## SITE PLAN REVIEW APPLICATION

## PLAN EXAMINATION

<p><b>PROJECT/SITE DESCRIPTION:</b>          Germantown Townhouses</p> <p><b>PROJECT ADDRESS:</b> W140 N10385 Fond Du Lac Ave          Germantown, WI</p> <p>PLAN REVIEW EXPIRATION DATE: 09-17-2025</p>	<p style="text-align: center;"><b>DETAILS:</b></p> <p>Review Type: Building          New Construction</p> <p>Plans Date: # 3/15/24,5/23/24,8/14/24,9/13/24          of Sheets: 22 of 35</p> <p>Project Area (sq. ft.): 7,684 SQ FT</p>
--	--

## Plan Specific Items:

Sheet No. **A201**

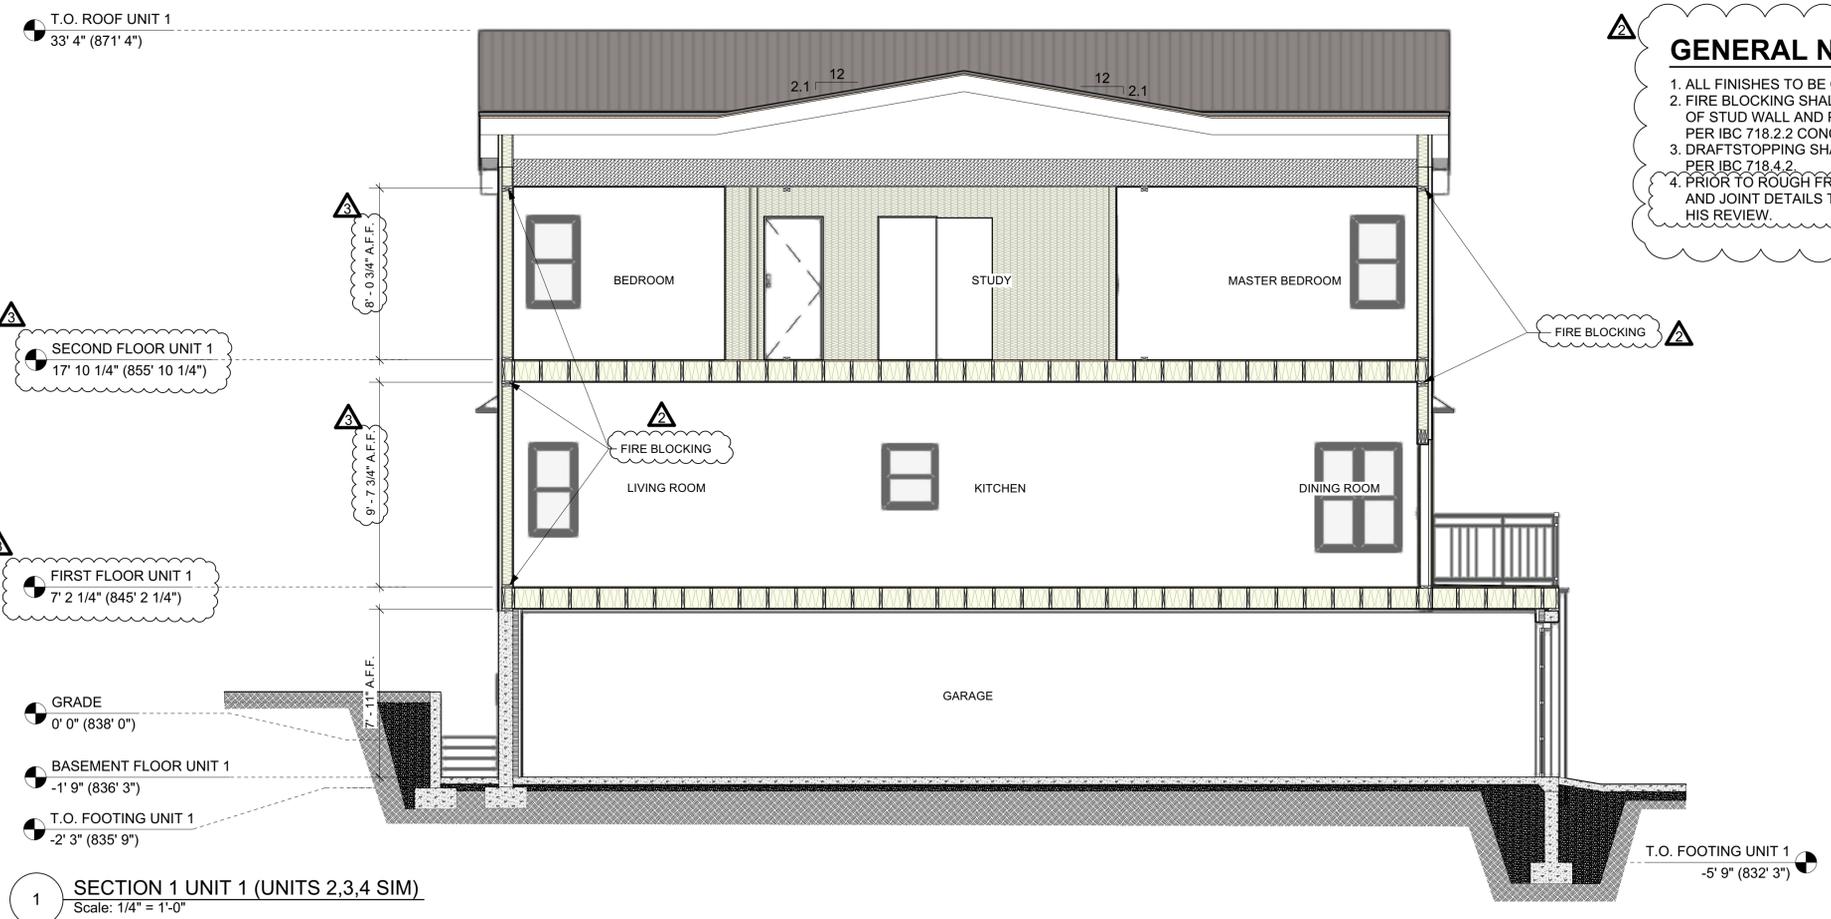
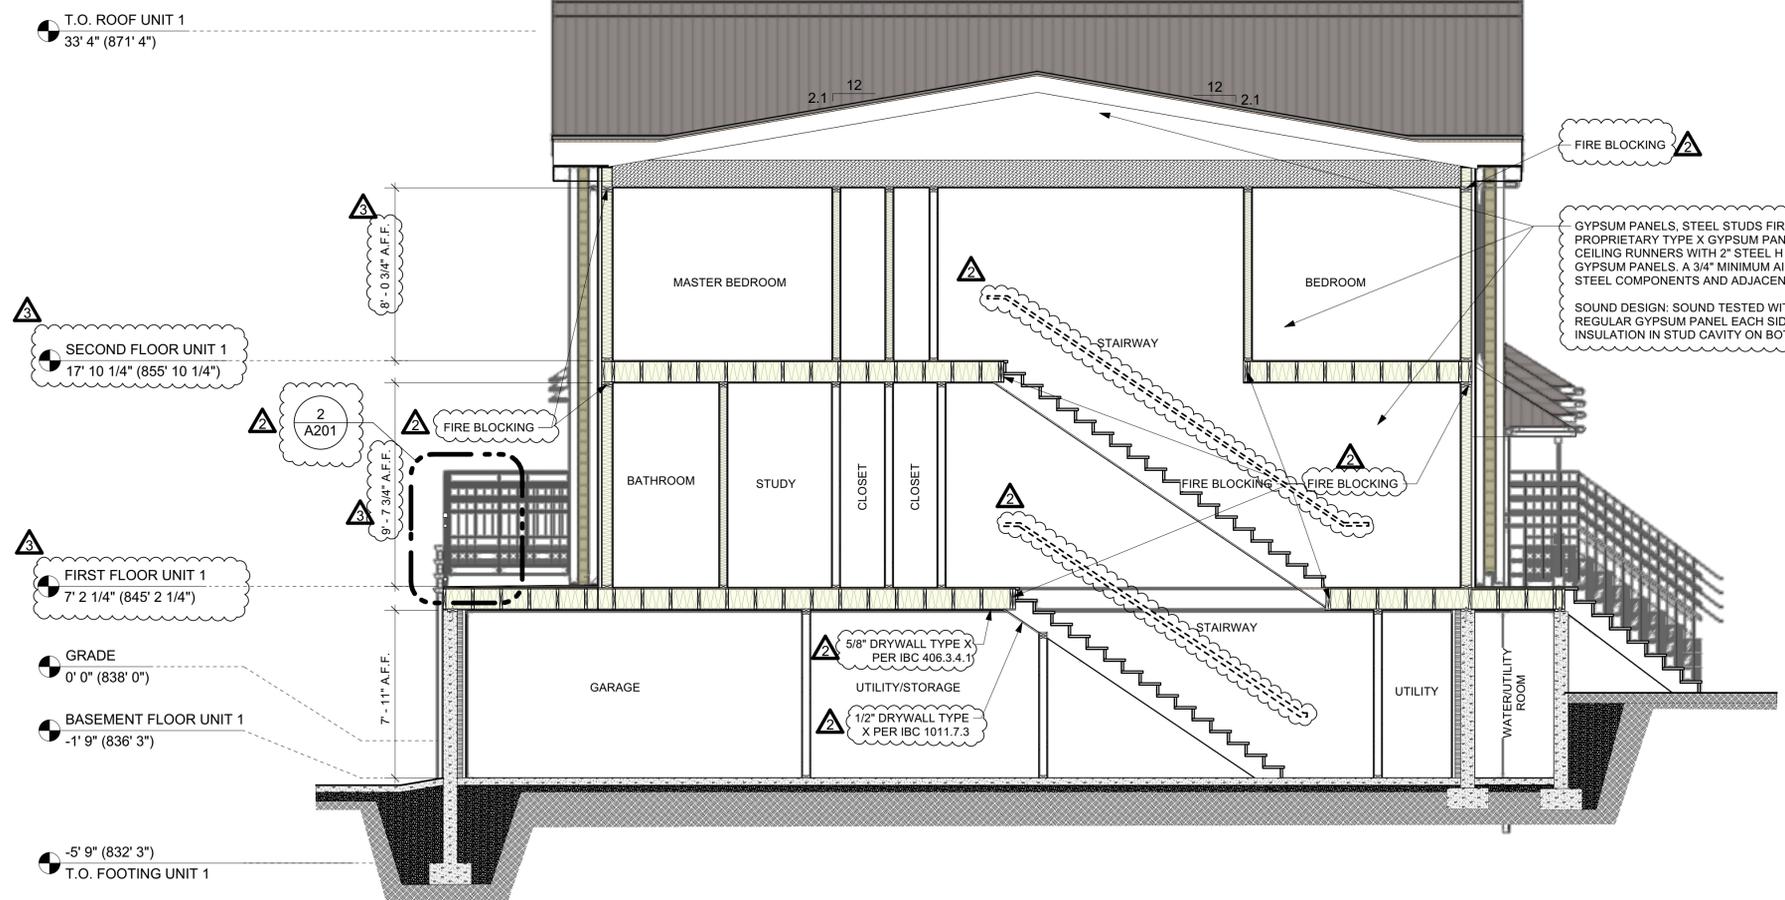
- Previous verbiage to extend fire partition to underside of sheathing has been removed from sheet A202 & A203. Per this code section, 2-hour fire resistance to extend to underside of roof sheathing.

6. **Not Resolved** IBC Section 708.4 Fire Partition, Continuity – Demonstrate fire partition compliance with this section at separation of units. Provide details.  
*POR Response: Acknowledged. We will provide the Code summary in revised drawings. Ch.6.602.5, Table 601. We will follow construction type 5B which does not require fire rated assemblies and all units will be sprinklered. – See Sheet # G003.*  
*SB Response: Repeat Comment – Demonstrate compliance with this section and Section 708.3 Fire-Resistance Rating. Provide required separation. Provide UL details on drawing.*  
*POR Response: The wall will be constructed per IBC Section 722 Calculated Fire Resistance, section 722.6 Wood Assemblies table 722.6.2(1) and 722.6.2(2). See wall type 1 - See sheet # A203.*  
*SB Response 04/03/24: Party-wall / firewall required to be 2 hour wall per Table 706.4. Continuous air space in concealed space from slab to roof deck as shown in wall type on sheet A203 does not provide required 2 hour firewall. See section 718.*

*Per Section 706.5 Horizontal continuity. Fire walls shall be continuous from exterior wall to exterior wall and shall extend not less than 18 inches (457 mm) beyond the exterior surface of exterior walls. Indicate with detail on plan which exception you are using to comply with this section.*  
*Per Section 706.5.2 Horizontal projecting elements. Fire walls shall extend to the outer edge of horizontal projecting elements such as balconies, roof overhangs, canopies, marquees and similar projections that are within 4 feet (1220 mm) of the fire wall. Indicate with detail on plan which exception you are using to comply with this section.*  
*Per Section 706.6 Vertical continuity. Fire walls shall extend from the foundation to a termination point not less than 30 inches (762 mm) above both adjacent roofs. Indicate with detail on plan which exception you are using to comply with this section.*

**SB Response 09/17/24** - Previous verbiage to extend fire partition to underside of sheathing has been removed from current sheet A202 & A203. Per this code section, 2-hour fire resistance to extend to underside of roof sheathing.

**S100**

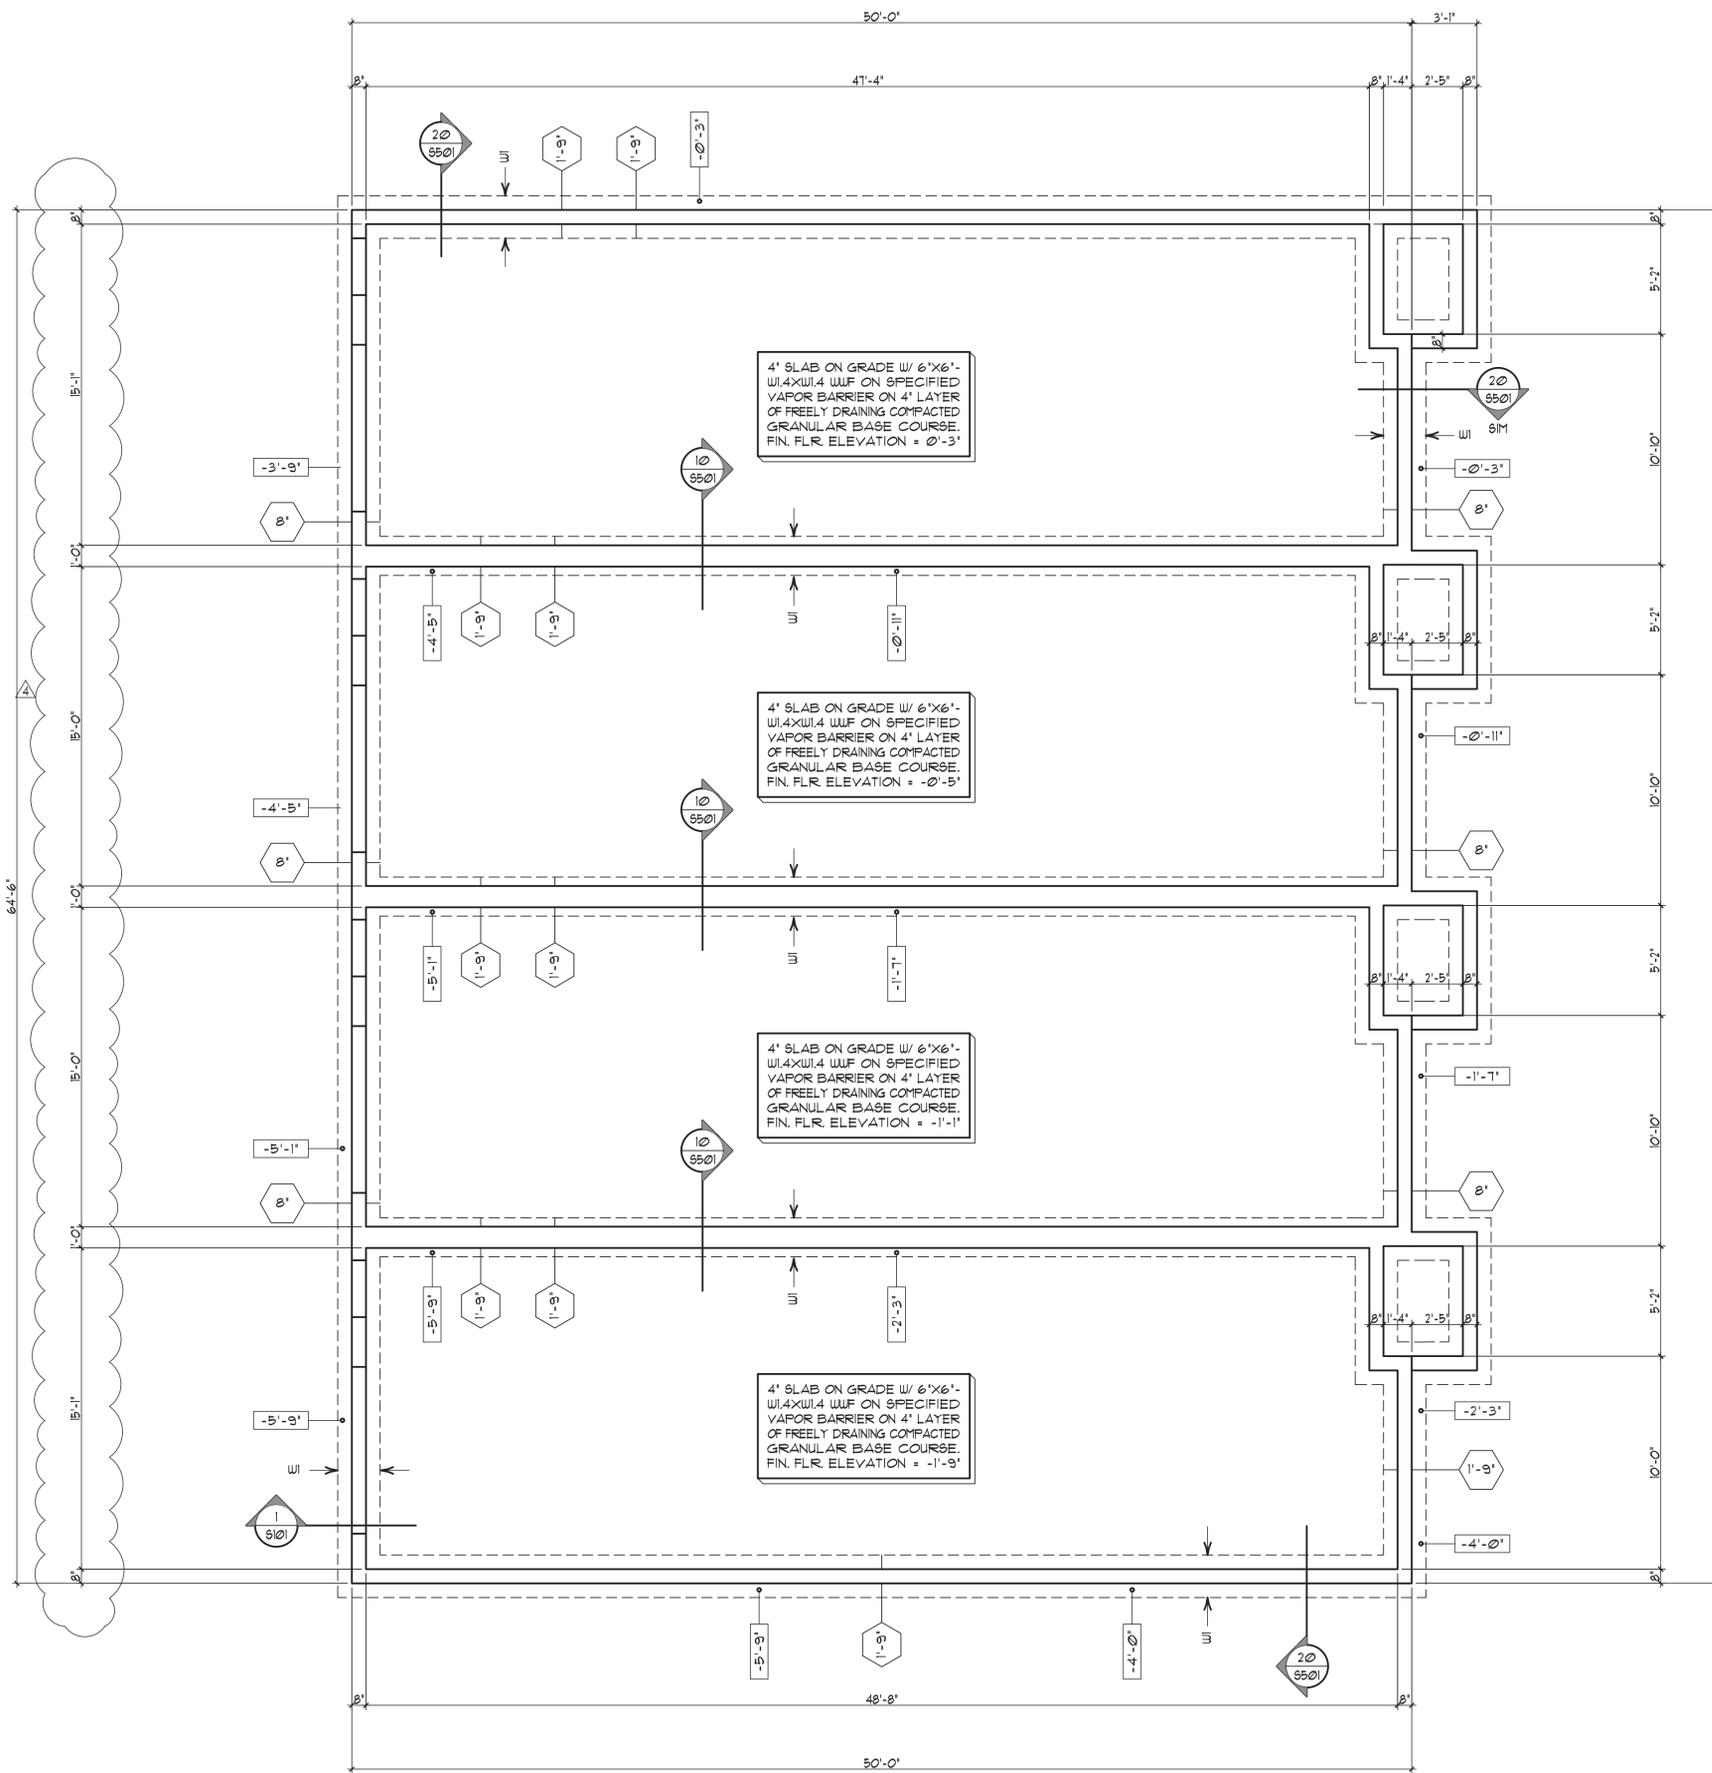
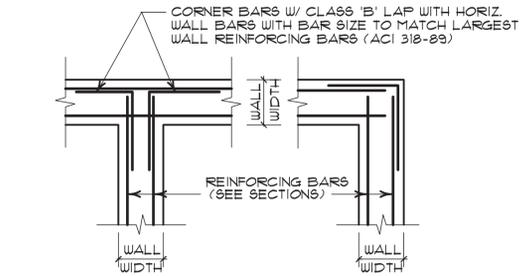
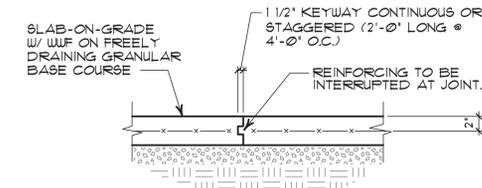
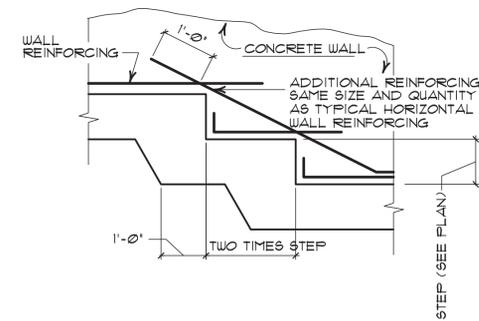
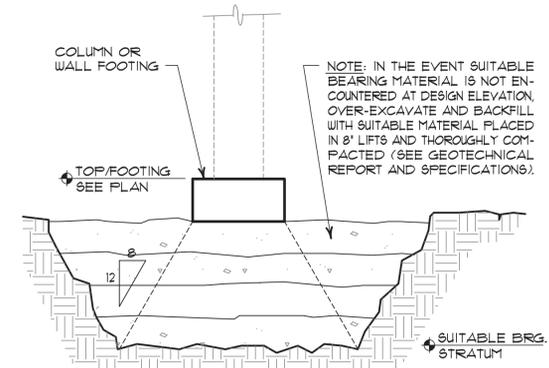
1. **Not Resolved** IBC Section 1803.2 Geotechnical Investigations – Provide geotechnical report.  
*POR Response: Acknowledged. Soil conditions are assumed. See Foundation and Earthwork note on sheet S500.*  
**SB Response 04/03/24:** The geotechnical report requirement shall be contingent on the Building Official's evaluation of soil bearing capacity verification by a qualified, registered professional. for footing and site excavations prior to first pour of foundations.

4. **Resolved 04/03/24 Per** S500, foundations have been designed for an assumed allowable bearing pressure of 3,000psf, calculations use 2,000psf. Correct disparity.
